Sydney Metro Sydenham to Bankstown Ancillary Facility Checklist

Assessment Name	Carrington Road Ancillary Facility and Laydown
Location	Way Street, Marrickville
Prepared By	Chris McCallum
Revision	Rev 2
Date required by	23 September 2023

Handover Sydney Metro Principal Contractors Form

DRAWING TITLE:
COMPOUND SERVICE PROTECTION MEASURES
SITE PLAN

LEP Heritage Layer

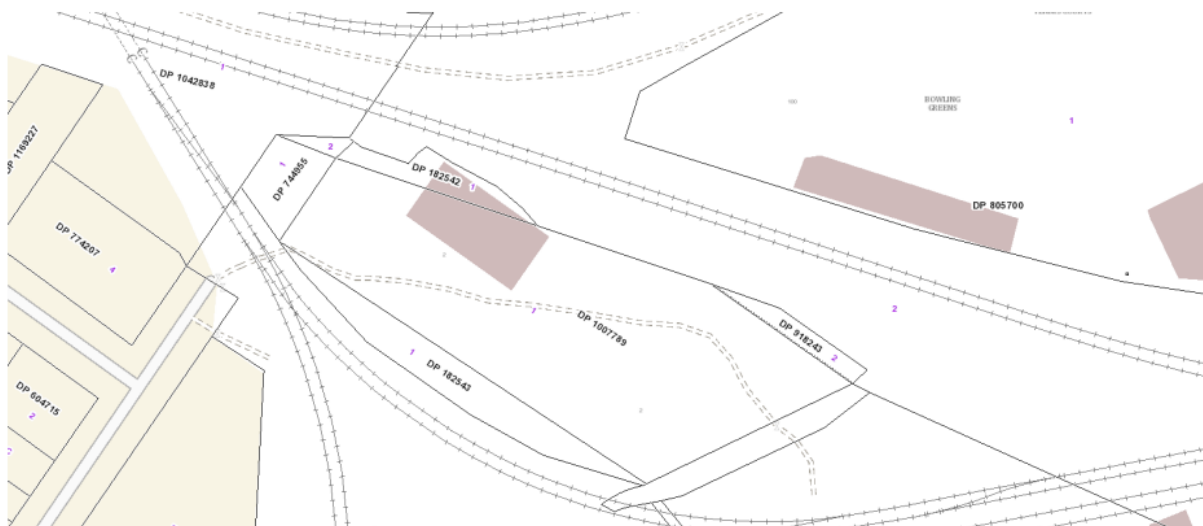
Stockpiles are to be located outside and to the west of heritage area 167.

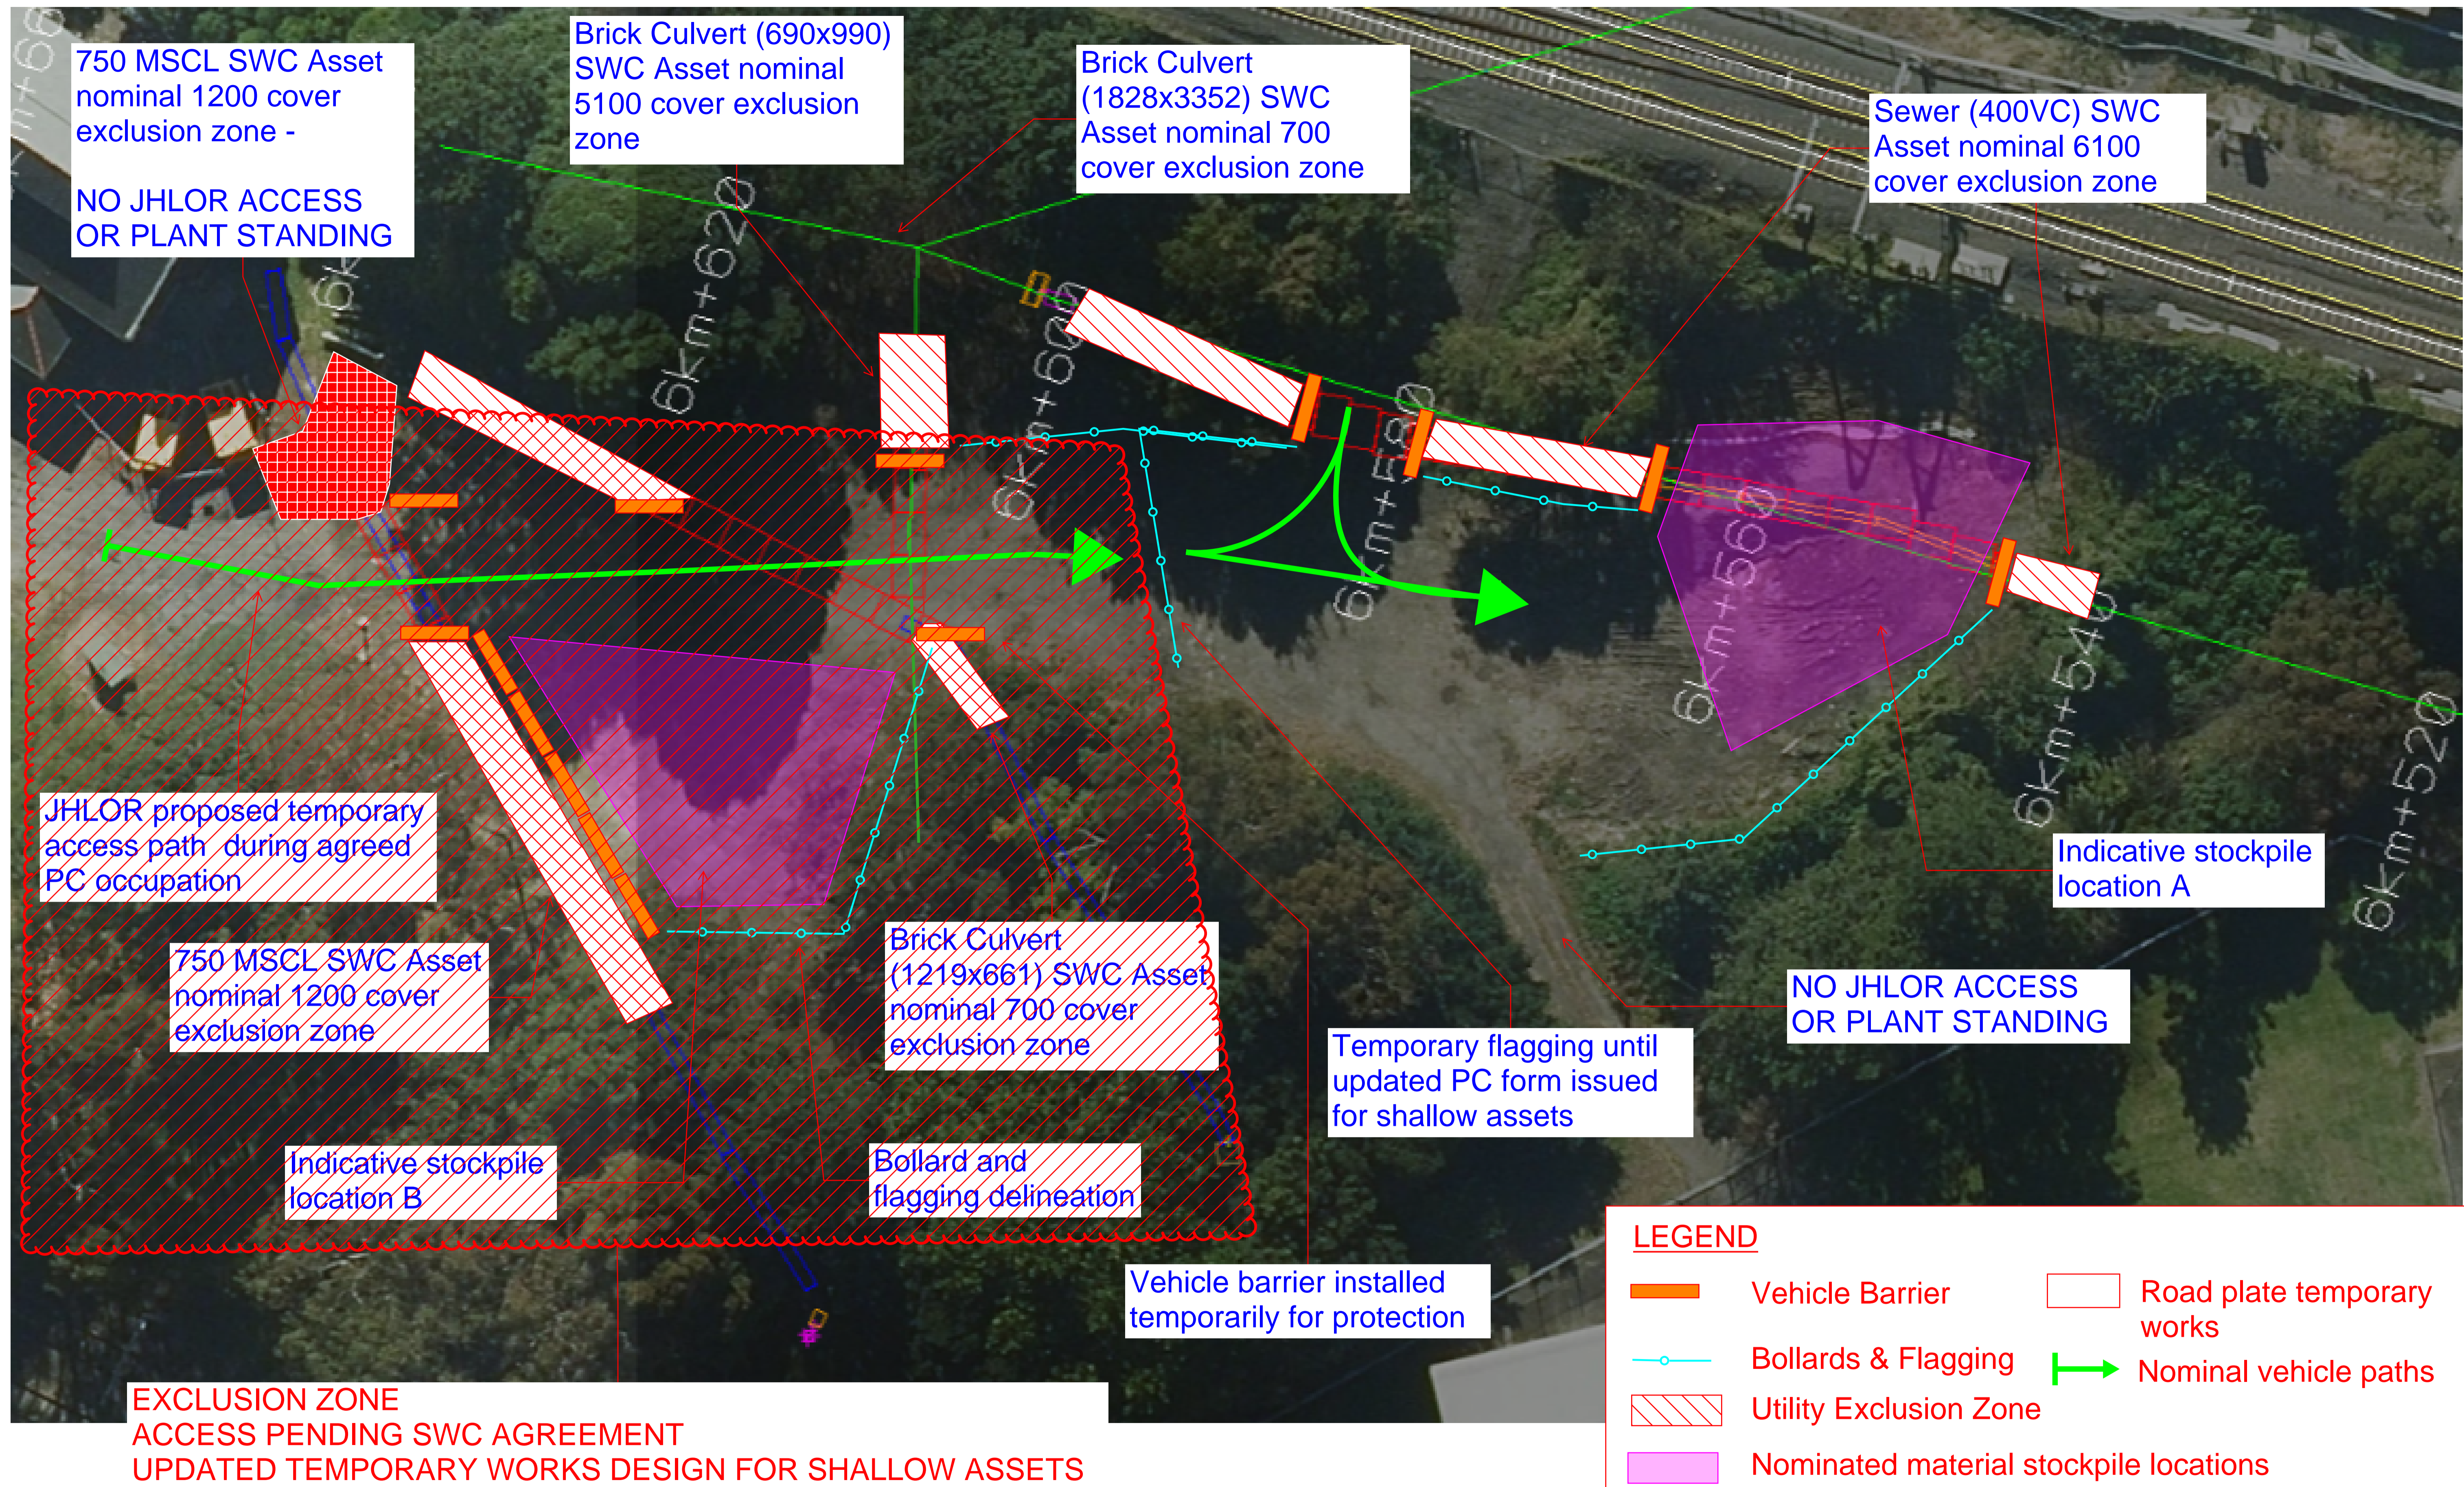
POSSESSION No.	SCOPE	SPECIFICS	JHLOR ACCESS REQUIREMENTS	SWC COMMENTS
WK01-WE03 (23/09/2023 to 05/10/2023)	Sydney Metro track and security fence civil works	Site access and stockpiling for spoil & import materials (ballast, DGB) for fencing and track works. <u>Refer to the markup attached.</u> Dayshifts commencing from 23/09/23. Target stockpile material removal planned for completion by 24/11/23	Access/Egress for a hi-rail plant will be via temporary track ramp and fence opening. Uninterrupted access to all Sydney Water Corporation (SWC) assets/compounds. Access to ARTC / Sydney Trains assets will be maintained clear at all times.	Plant spotters to be in place at all times where vehicle movements occur to ensure existing aerial cables are free from damage & SADs are maintained & vehicle movements over unprotected SWC assets do not occur Condition inspections to be complete by the following dates. 1. Prior to 23/12/2023 2. Prior to conclusion of Lease (April 2023) Form to be resubmitted prior to any of Part B access and stockpile locations being used by JHLOR. Resubmission to include update to Temporary Works for shallow assets noted in hatched section on page 3

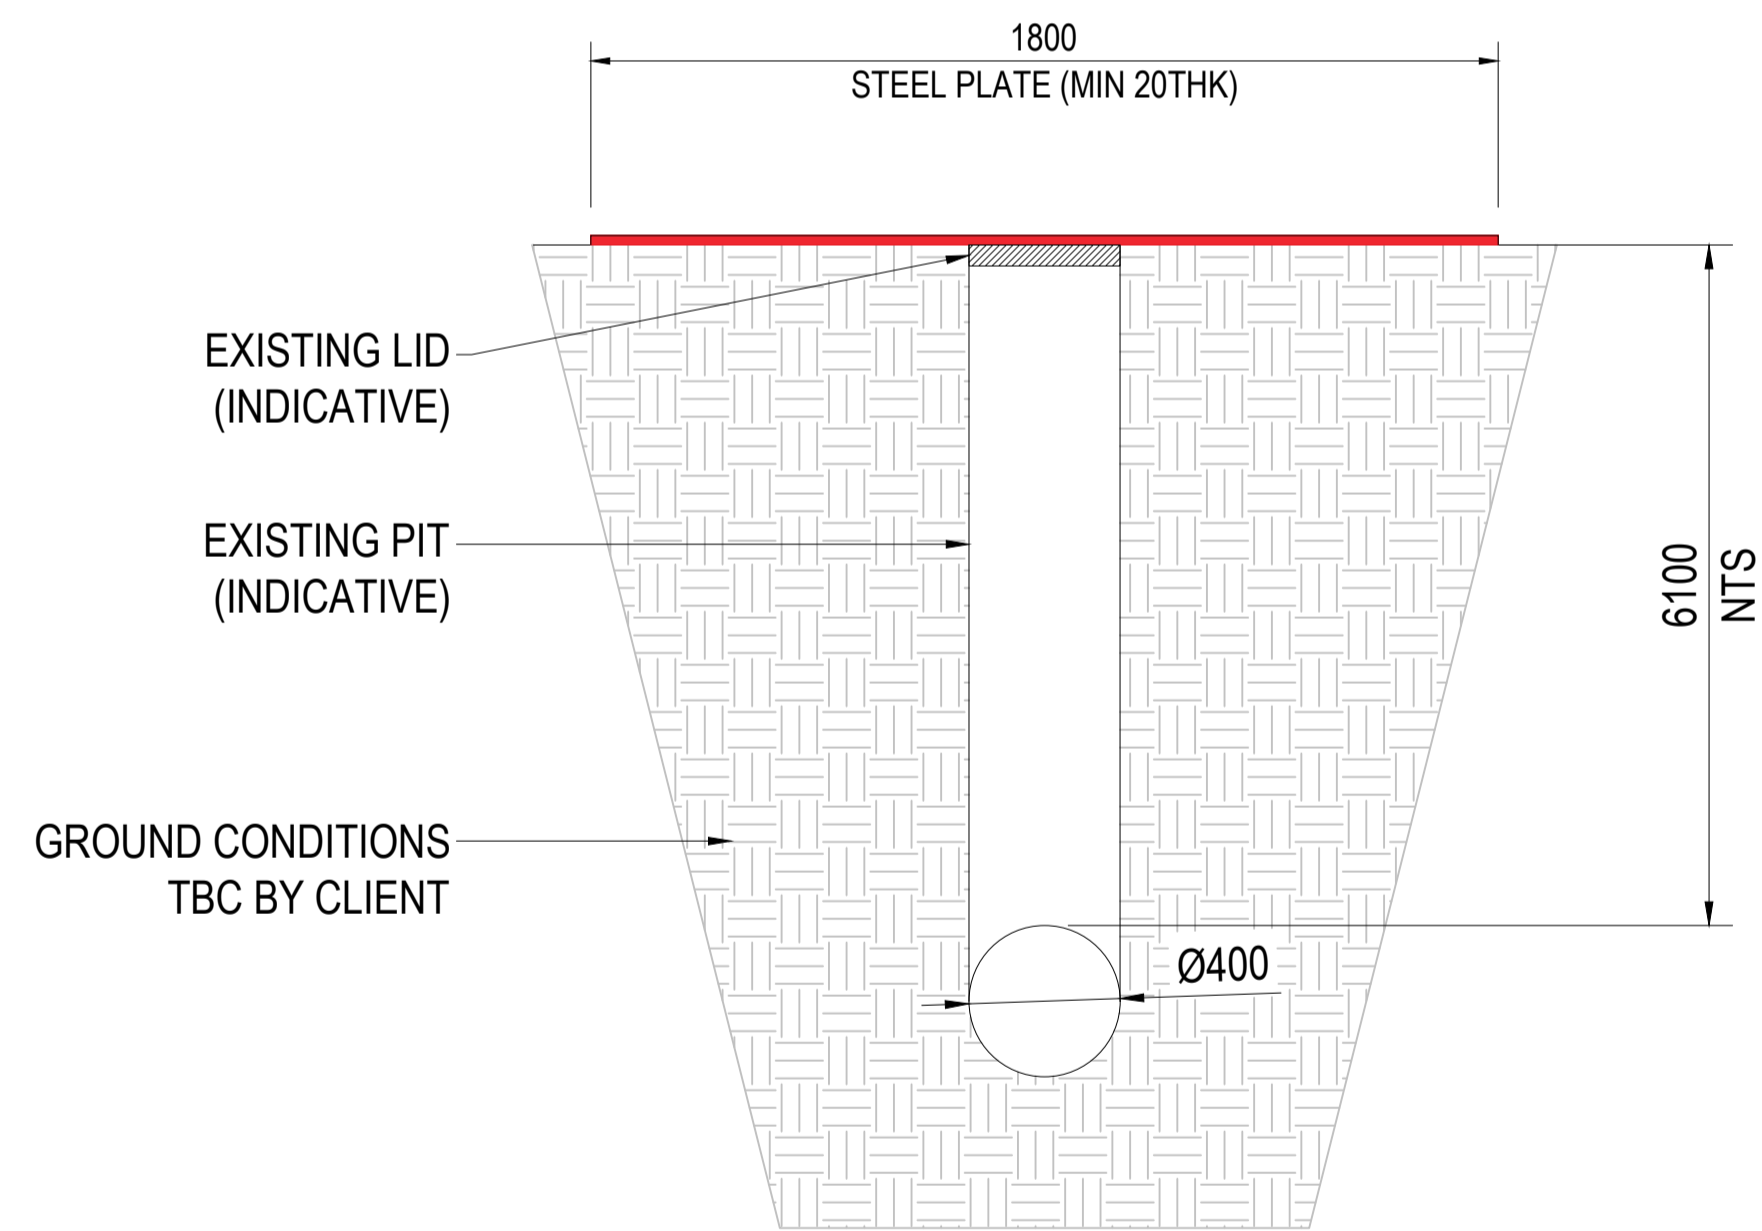
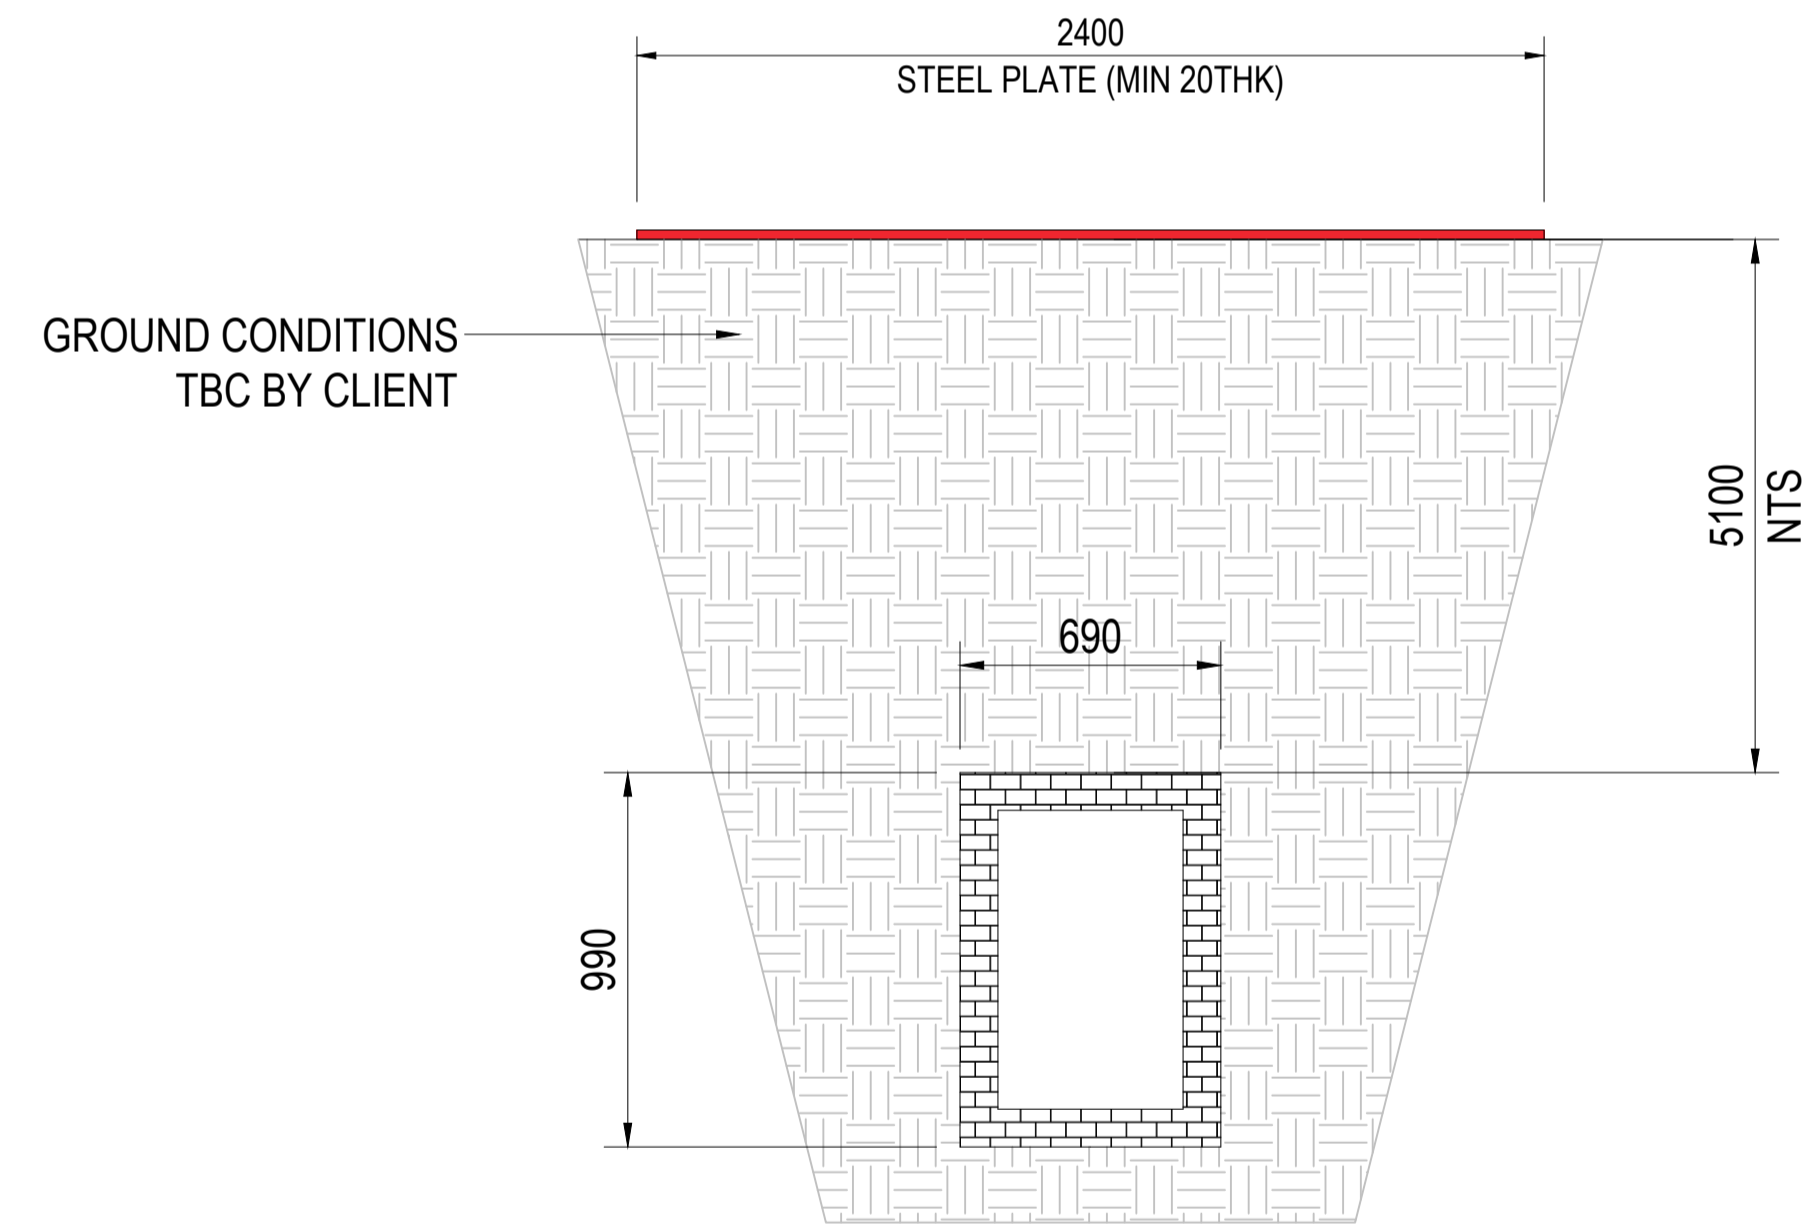
Pending updated SWC agreement
